TRANSMISSION—ALL—VEHICLE CAN BE SHIFTED OUT OF “PARK” WITHOUT DEPRESSING BRAKE PEDAL—ECONOLINE CUTAWAYS ONLY AND F-SERIES BUILT THROUGH 2/28/95

**Article No.
96-8-18**

FORD: 1994-1995 BRONCO, ECONOLINE, F SUPER DUTY, F-150-350 SERIES

Figure 1 - Article 96-8-18

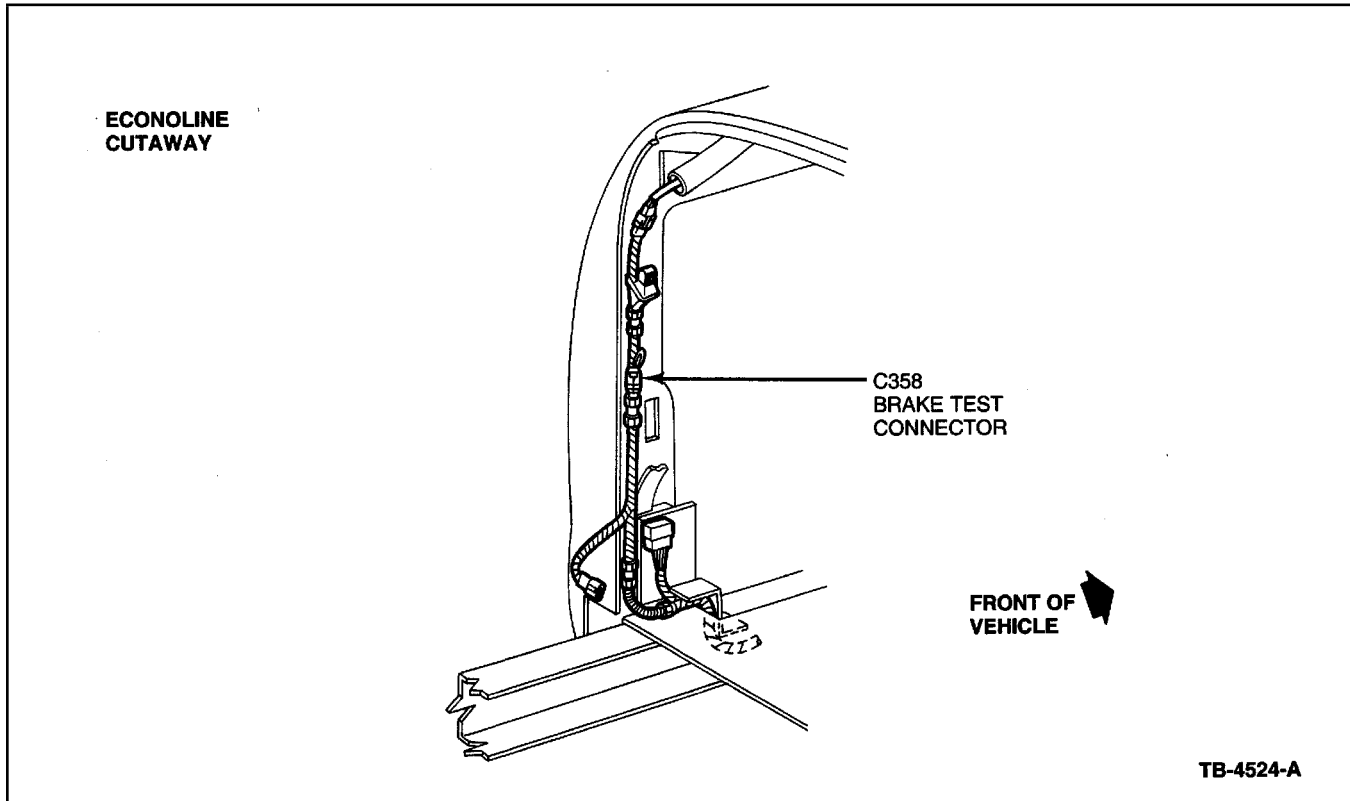
The customer may be able to shift the vehicle out of “Park” without depressing the brake pedal on some vehicles. This may occur if no high mount stoplamp is installed or the bulb filament is either missing or open, simulating the brake pedal being depressed.

1. If a high mount stoplamp is installed, check to make sure the bulb filament is not missing or open. Repair as required.
2. Locate the -14A200- wire harness along the B-pillar behind the driver's seat.
3. Locate brake test connector C358, Figure 1. This is a 2-way gray connector.
4. Install the jumper into the connector.
5. Wrap the main body wire harness with polyken tape. This will hold the connector in place and prevent any rattles of the connector to the B-pillar.

Install a jumper harness with a resistor to simulate the presence of a high mount stoplamp or replace the high mount stoplamp if the bulb is open. Refer to the following Service Procedure for details.
